**TOWN OF NEWBURGH
PLANNING BOARD
TECHNICAL REVIEW COMMENTS**

PROJECT: SERVISS
PROJECT NO.: 21-07
PROJECT LOCATION: SECTION 14, BLOCK 1, LOT 48
REVIEW DATE: 30 APRIL 2021
MEETING DATE: 6 MAY 2021
PROJECT REPRESENTATIVE: TALCOTT ENGINEERING

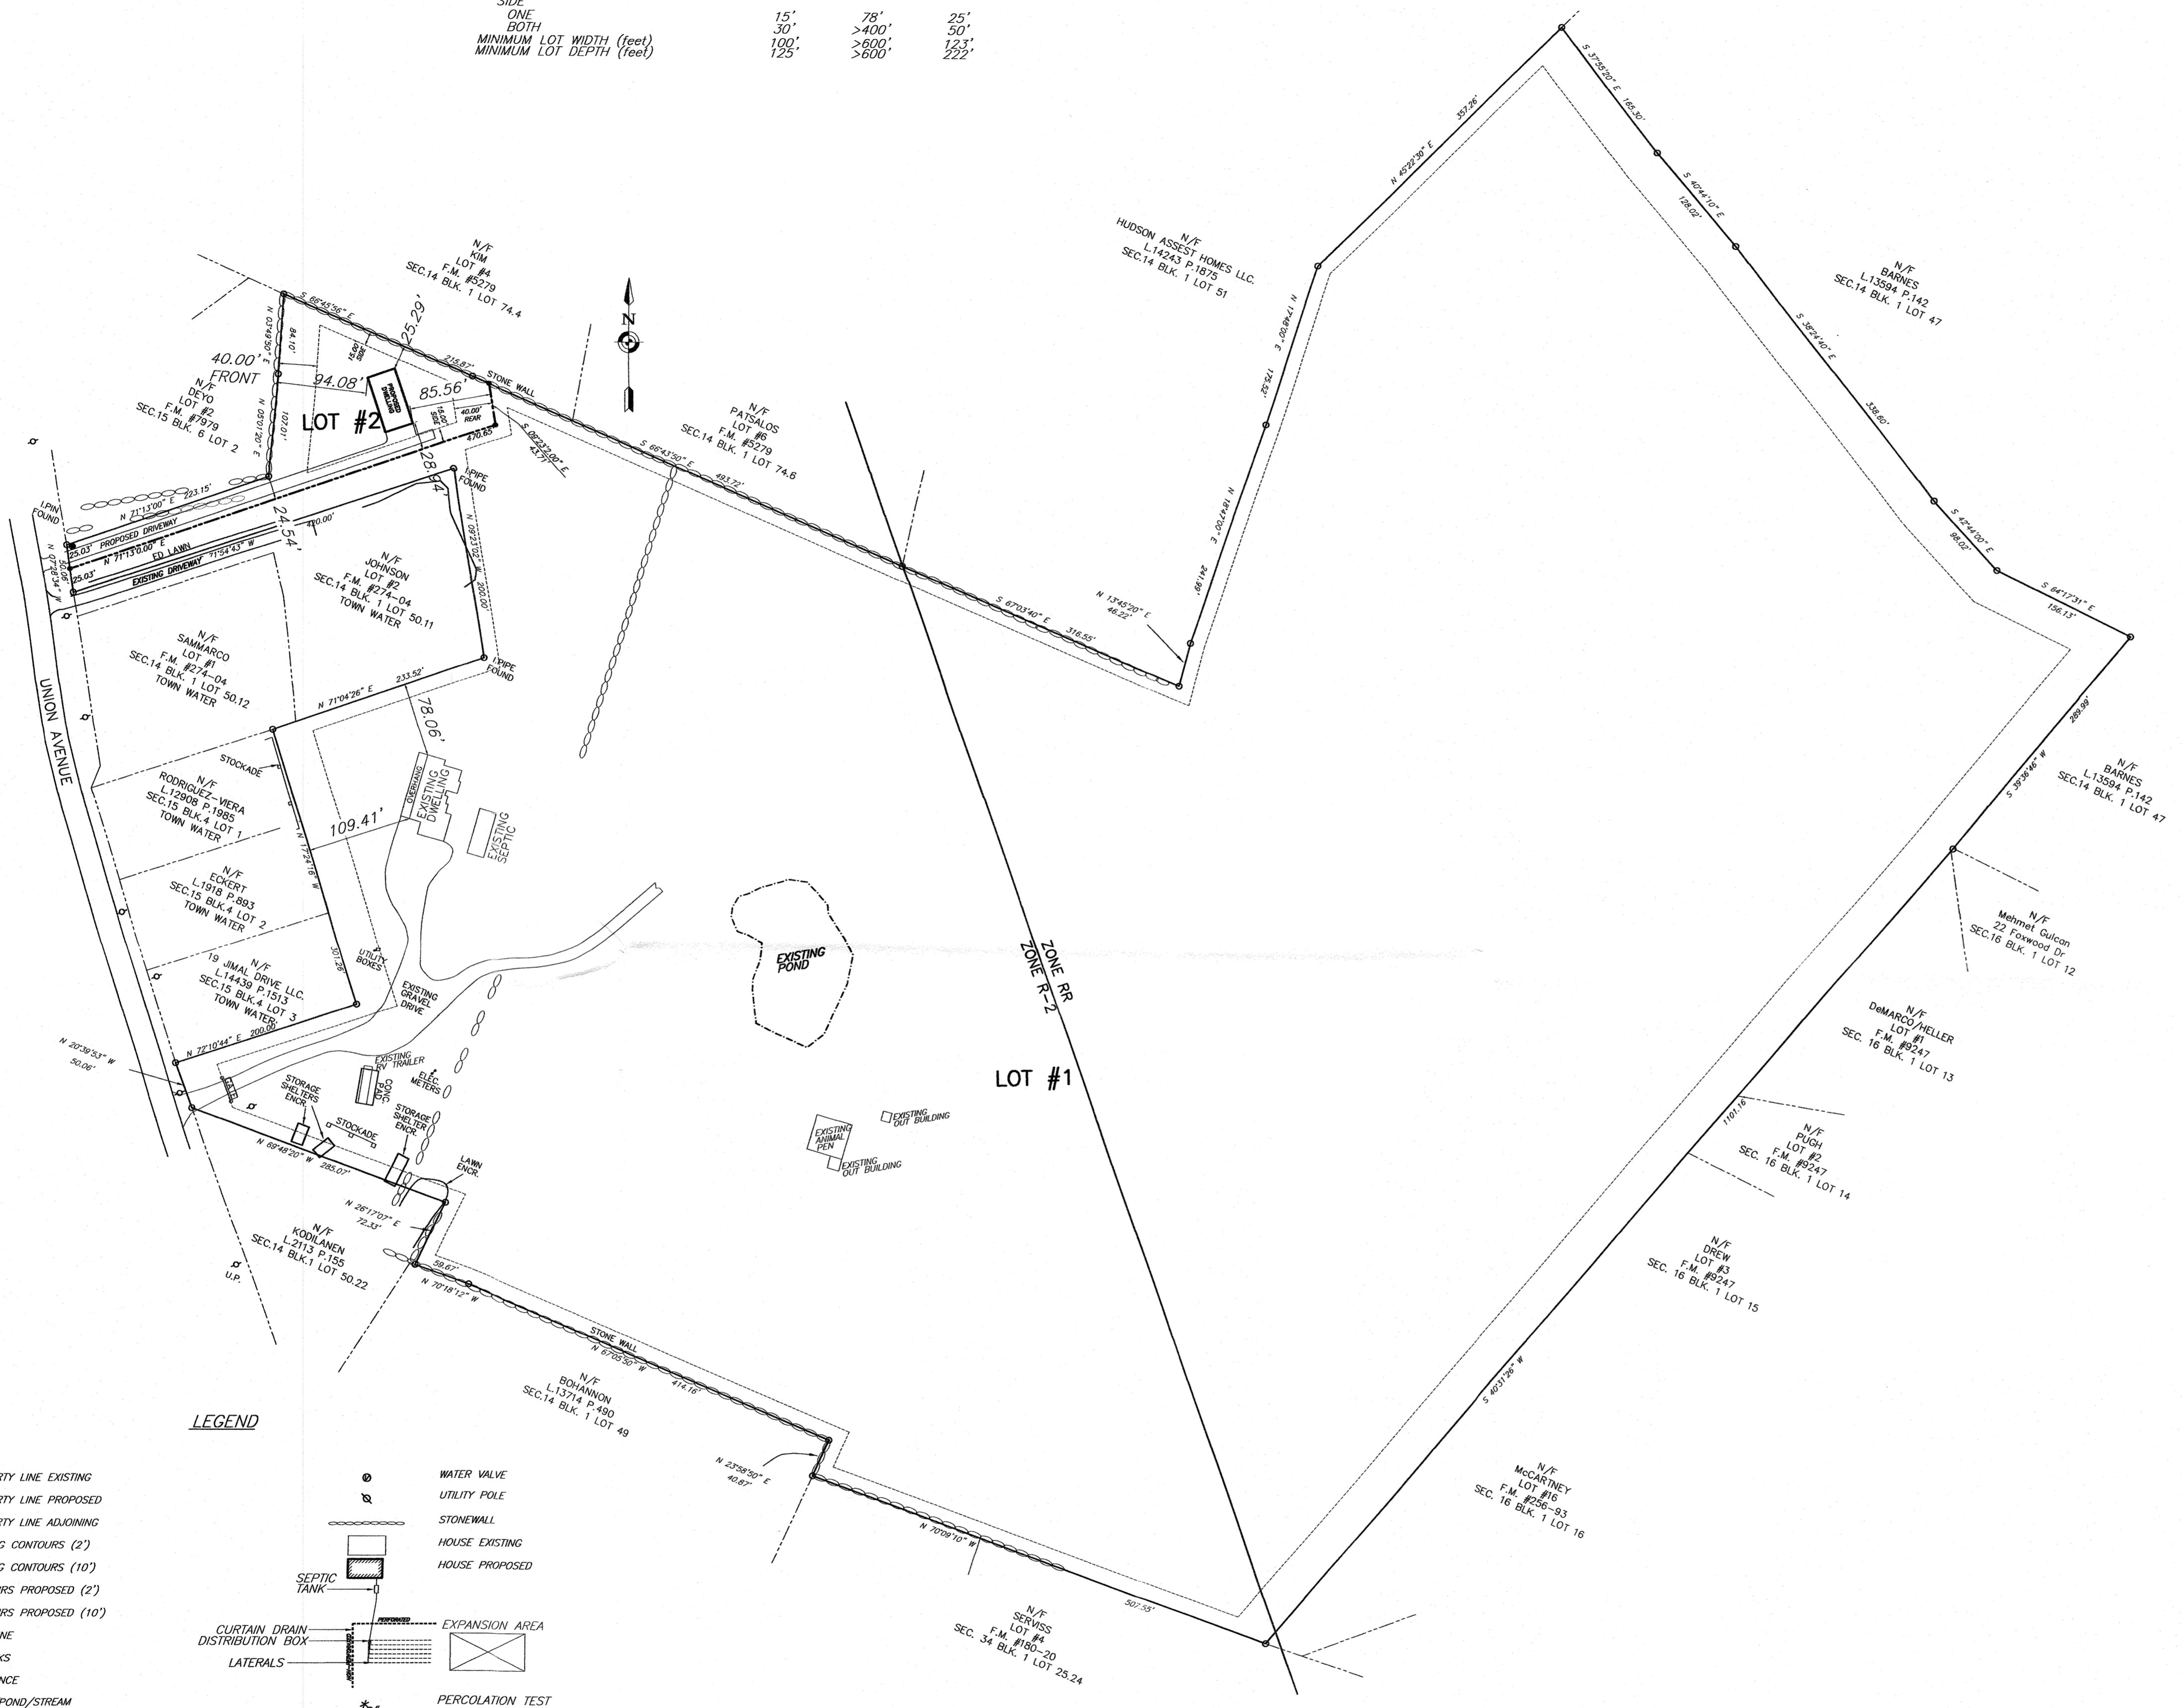
1. Comments from the Highway Superintendent should be received regarding the driveway access.
2. Location map at 1-inch = 2,000 scale should be provided for reference of the lot location.

3. The Bulk Table should be updated identifying R-2 Zone identifying that the project is proposing to be connected to Town water.
4. Location of the water service should be depicted on the plan sheets.

5. Driveway grading should depict -2% from Union Avenue into the site. Appropriate culverts must be provided along the entrance drive.
6. Appropriate grading should be provided to retain runoff from the driveway on the proposed lot. Currently grading would allow drainage to flow onto adjoining lot.

7. The subdivision of this parcel from the parent parcel will restrict future access to the site from the 50-foot-wide spurt existing to Union Avenue.
8. A review of the tax records identify that a corporation and an LLC are the record owners of the property. Application identifies an individual as the owner, this should be further clarified.

9. County Planning referral is required as the property is located within 500-feet of the NYS Thruway corridor.
10. The application requires that all existing houses, accessory structures, wells and septic on

and within 200-feet of the parcel to be subdivided must be shown.

11. The applicant's representative is requested to address provisions for a shared driveway serving the proposed Lot #2, and continuing to serve proposed Lot #1. The current layout could result in three (3) driveways being located within 75-feet.
12. The applicant is requested to coordinate with the water department regarding the size of the service lateral for the project.
13. Revised (2015) water system notes should be added to the plans. **Copy of the revised water notes are attached.**
